Response to February 2024 Updates

Please find below a response to matters in respect of the proposed development plan for 99 Bena Road 19040 Revised Development Plan

99 Bena Road Korumburra 3950

**PROPOSAL:** DEVELOPMENT PLAN IN DPO6 AREA  
**APPLICANT:** PLANNING CENTRAL  
**ADDRESS:** 99 BENA ROAD, KORUMBURRA  
**DESCRIPTION:** LOT 1 ON PLAN OF SUBDIVISION PS321371

Figure 1 – Concept Plan

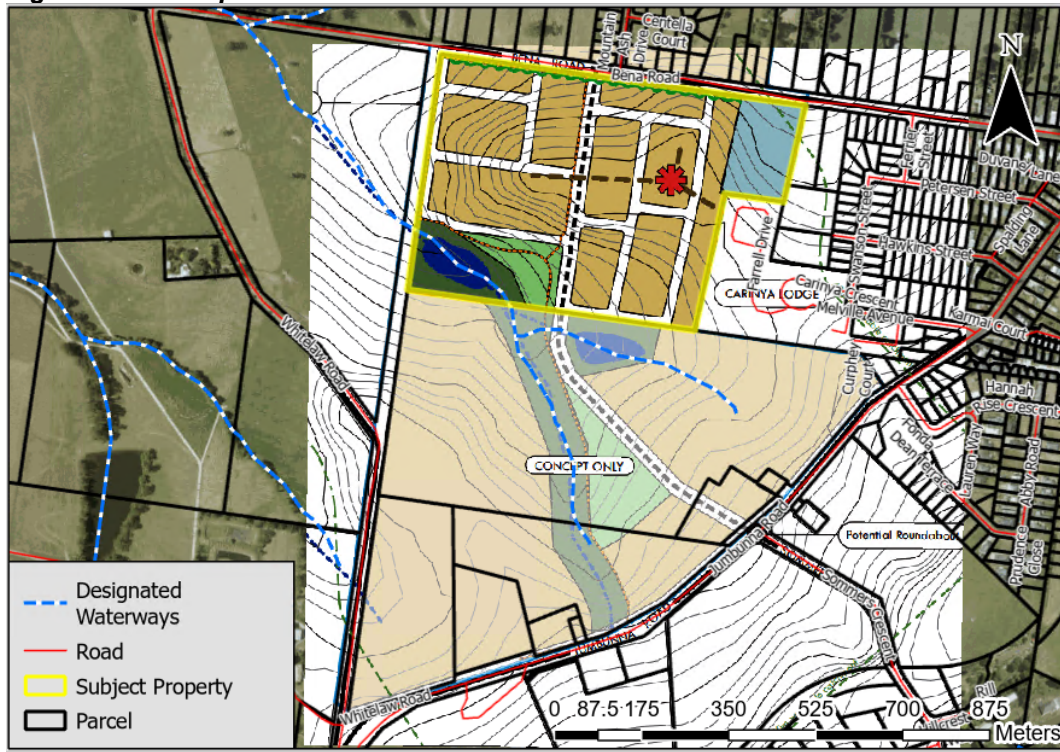
The Authority has reviewed the *Stormwater Management Plan – 99 Bena Road Korumburra* (Afflux Consulting, 14 February 2024) and is comfortable with the stormwater management concept that has been proposed. It is noted however, that it may be difficult to implement due to the steep terrain at the location where the wetland is proposed.

The Authority believes there may be benefit in locating the drainage reserve further to the south, across the property boundaries, and increasing its size so that the wetland can be located on marginally flatter land and to allow a larger single wetland to be constructed to treat stormwater from all properties rather than having two separate wetlands to treat stormwater from each area. The Authority is willing to consider conceding the requirement to protect the eastern most waterway should this approach be taken.

The Authority is satisfied that the width of the drainage reserves (waterway buffers) meets our requirements.

The Authority requests that the Development Plan documents, including the Landscape Plan, specifies that the drainage reserve/waterway buffer is required to be revegetated in accordance with a Waterway Management Plan (WMP) to the satisfaction of the Authority.

Figure 1 – Proposed Development Plan

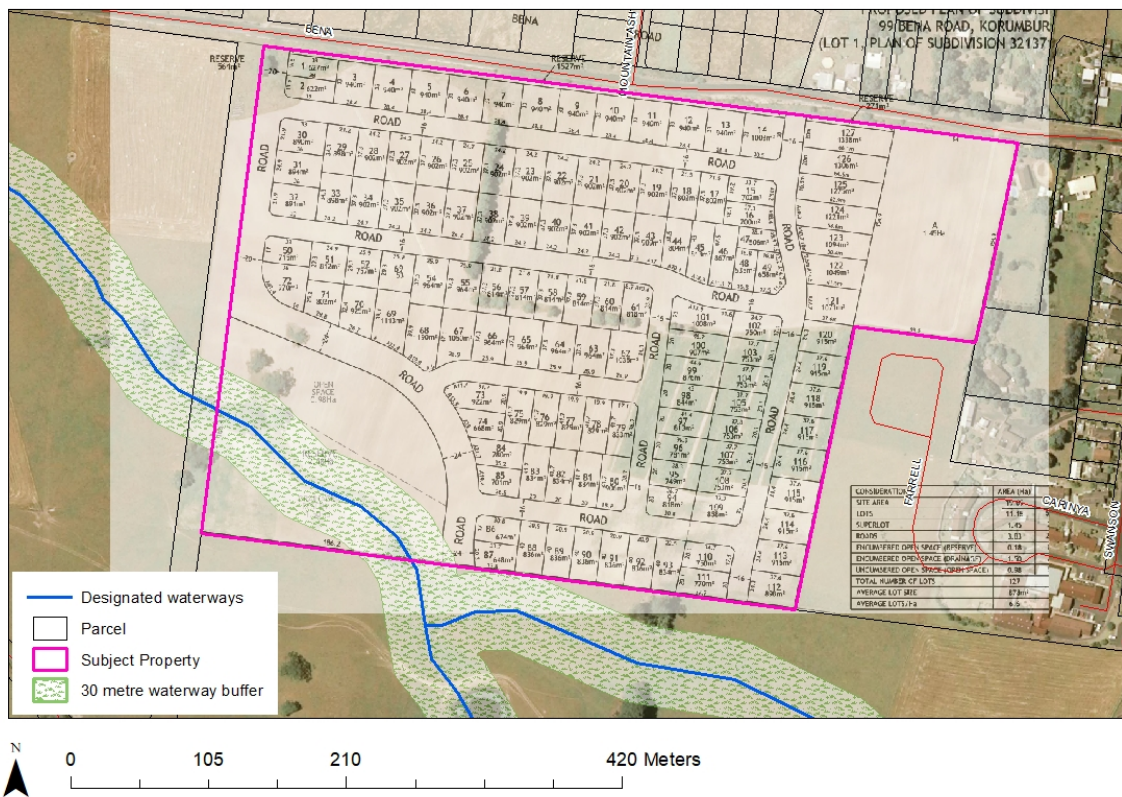
The Authority notes that the stormwater memo (Afflux Consulting, May 2022) in Appendix H of the development plan demonstrates conceptually that stormwater from the development can be managed and treated appropriately. The Authority will require a detailed Stormwater Management Plan (SMP) prior to certification of Stage 1 of the subdivision that clearly identifies how stormwater runoff from the entire development will be managed and treated prior to discharge to the designated waterways including the proposed timing of works. It must also quantify the reduced loads of sediment, nutrient, and gross pollutants in kg/year.

The Authority cannot support a reduced buffer of 40 metres. The development plan layout will need to ensure that the required 60 metre buffer has been incorporated and that the proposed road and lot configuration do not encroach on this buffer area.
